# North Dakota Department of Transportation

## ADDENDUM 2 – JOB 7

TO: All prospective bidders on Project SC-4718(060), Job No. 7 scheduled for the November 9, 2018 bid opening.

## ADDENUM 2 – JOB 7

THRIE/W-BEAM GUARDRAIL LAYOUT  
Co. Rd. 42  
Buchanan West Approximately 5 Miles  
Stutsman County, North Dakota

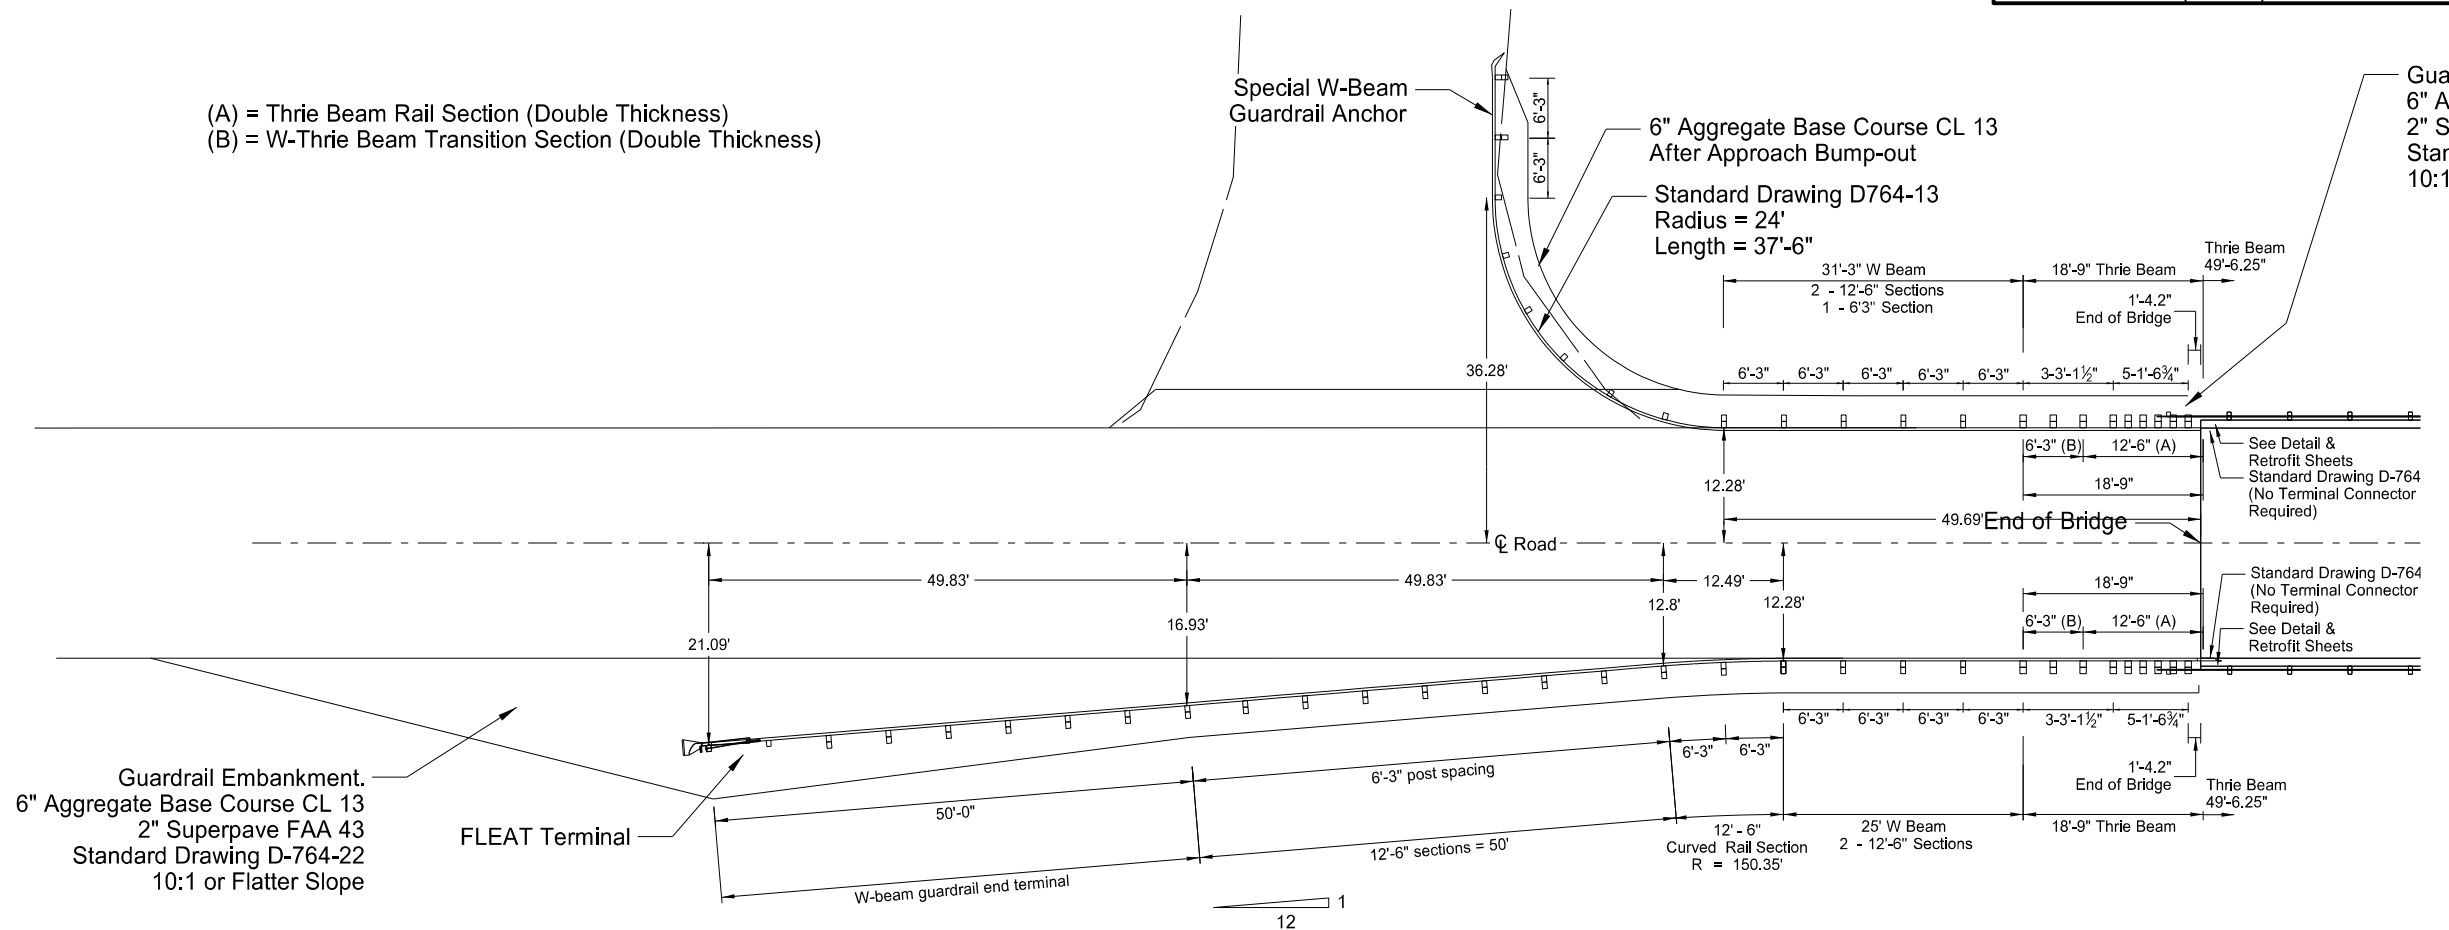
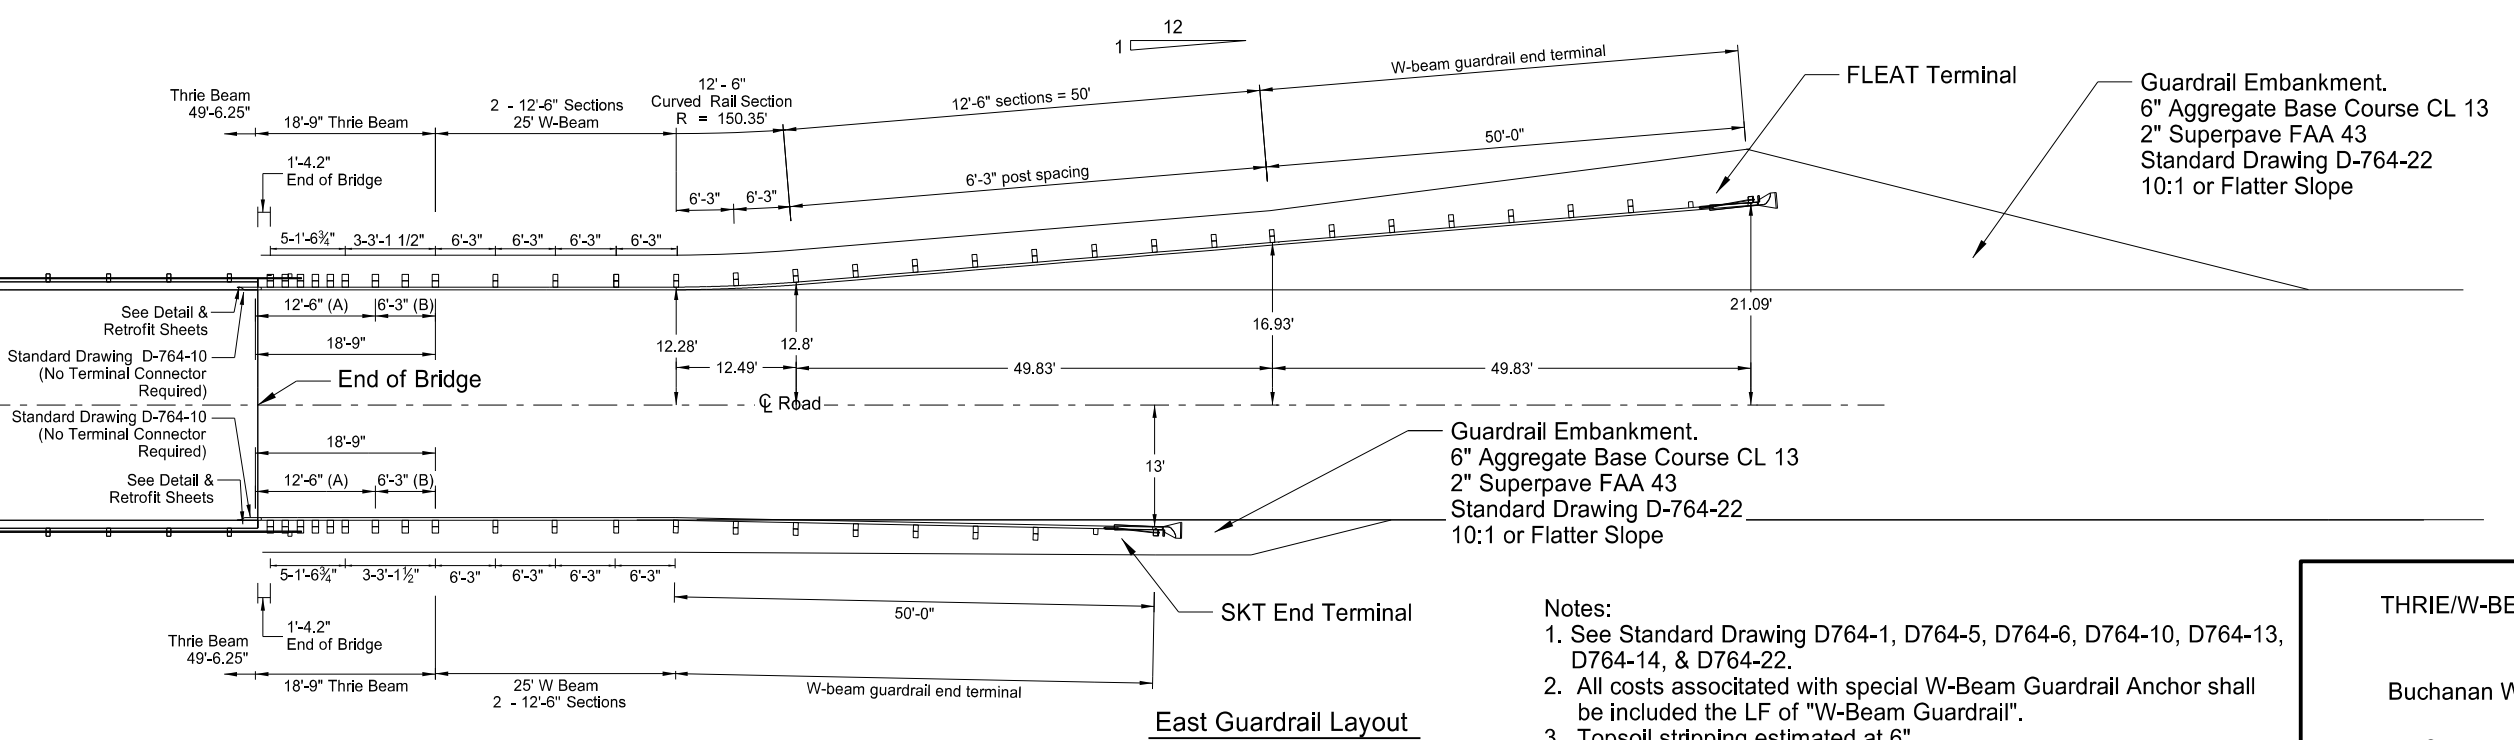
Added guardrail layouts.

**BRIDGERAIL REMOVAL & LAYOUT**  
Co. Rd. 42  
Buchanan West Approximately 5 Miles  
Stutsman County, North Dakota

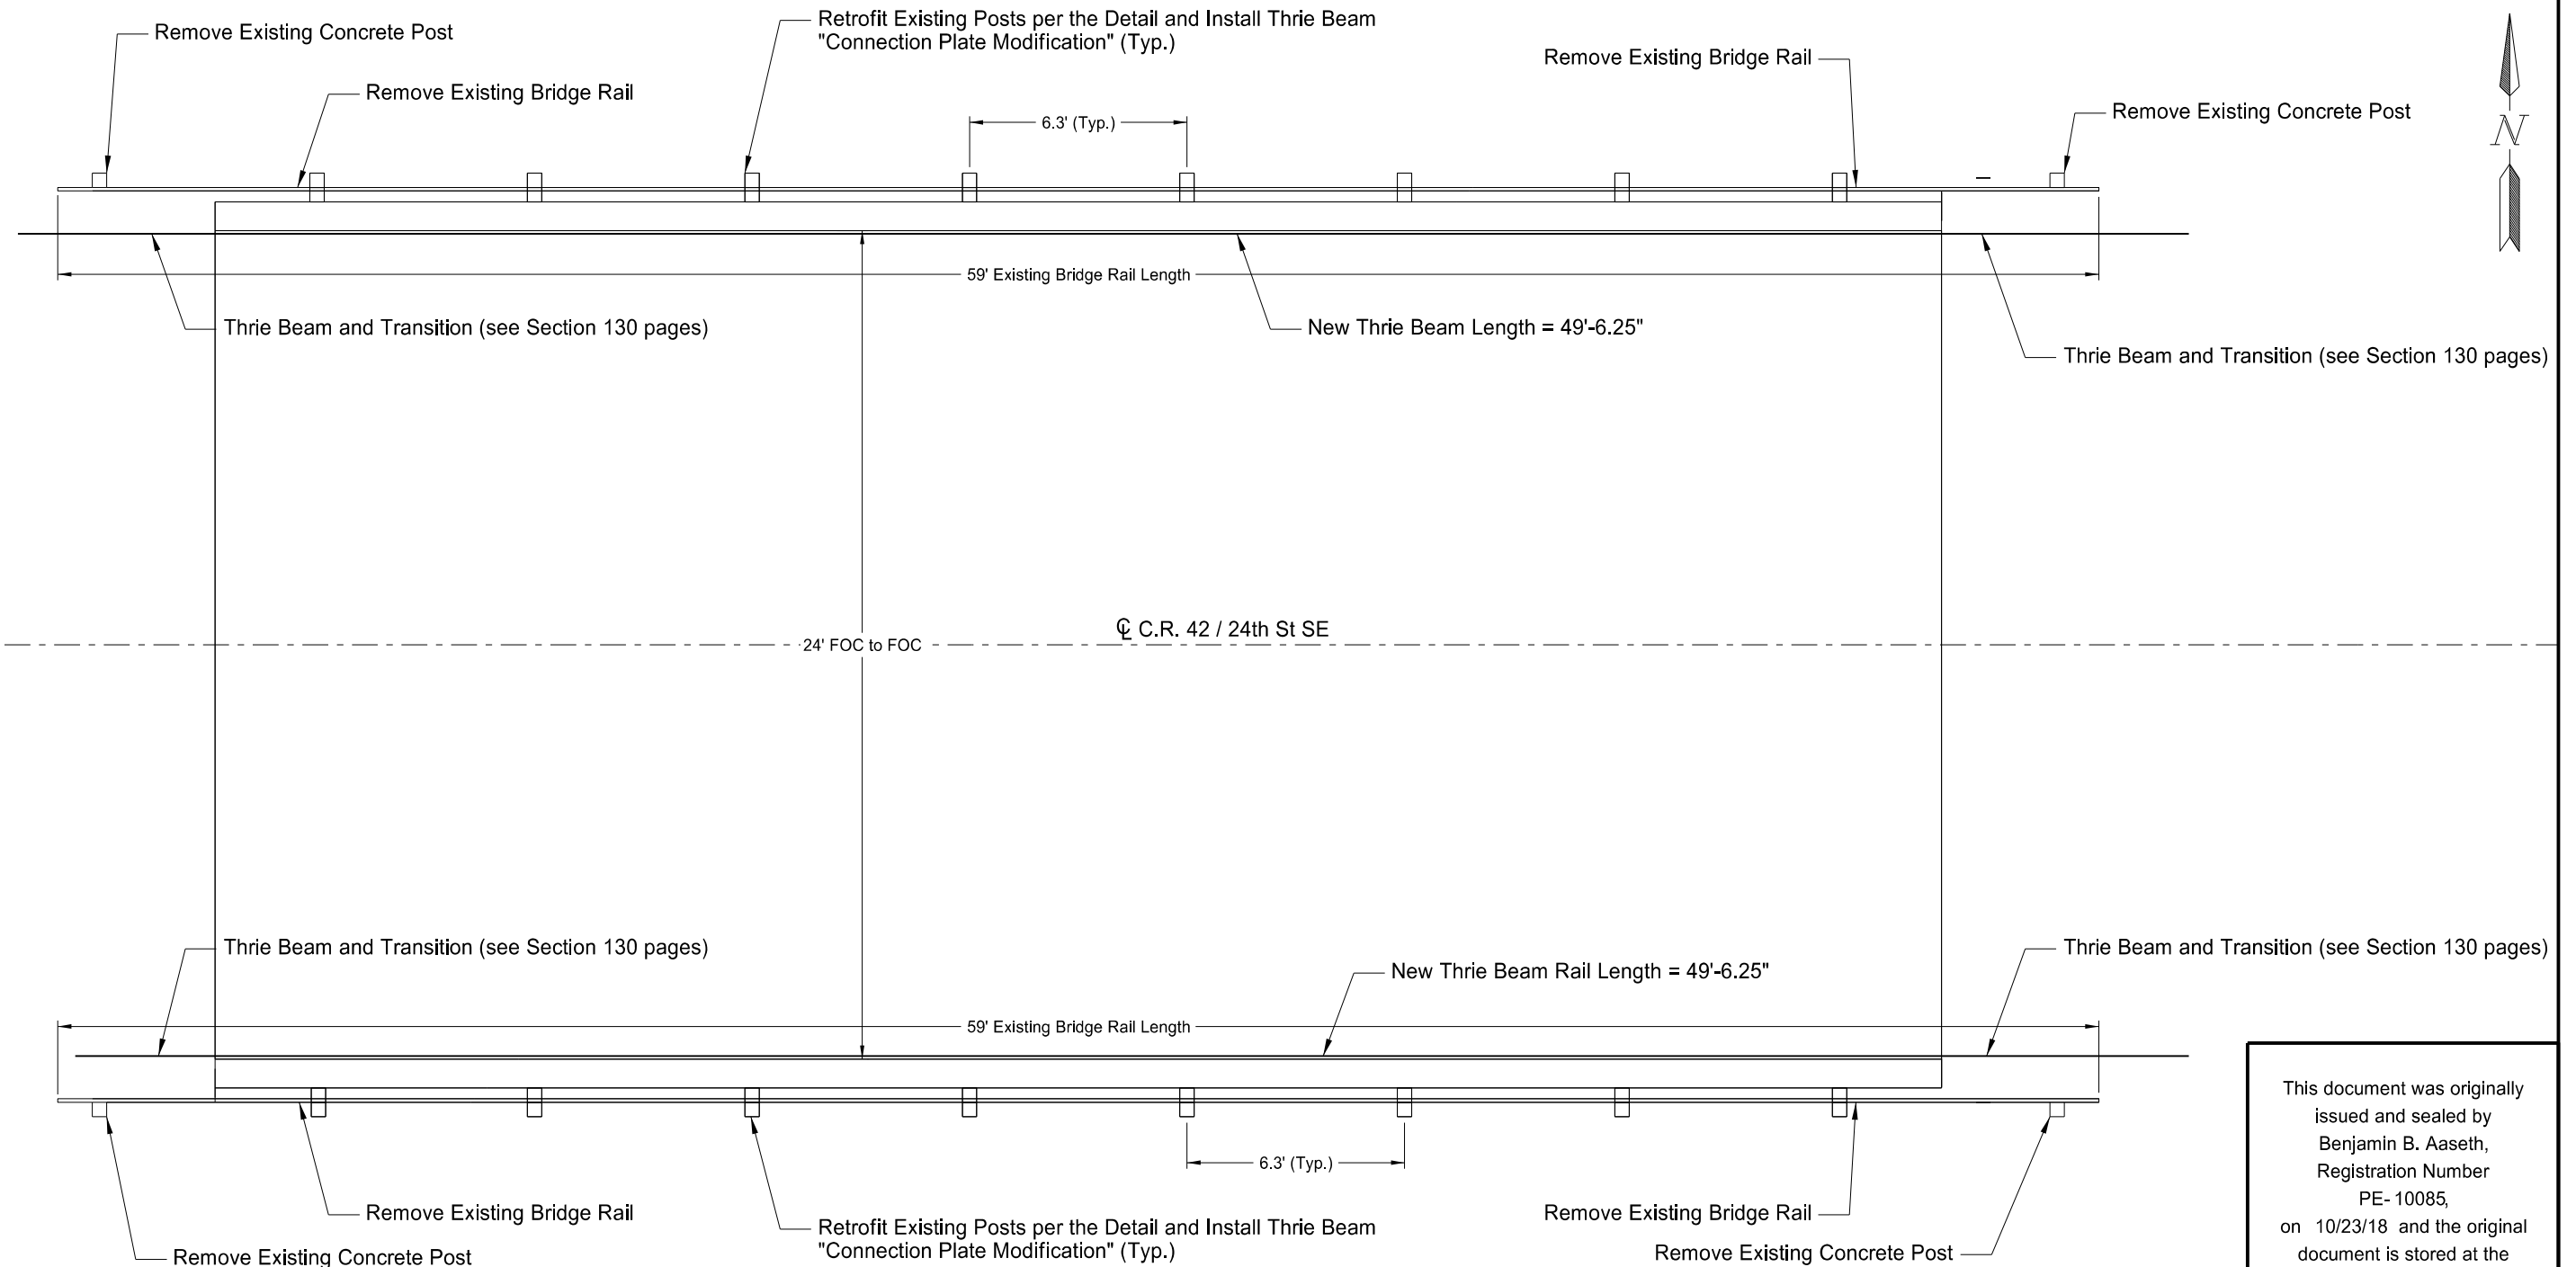
Added Bridge Rail Removals and Modifications.
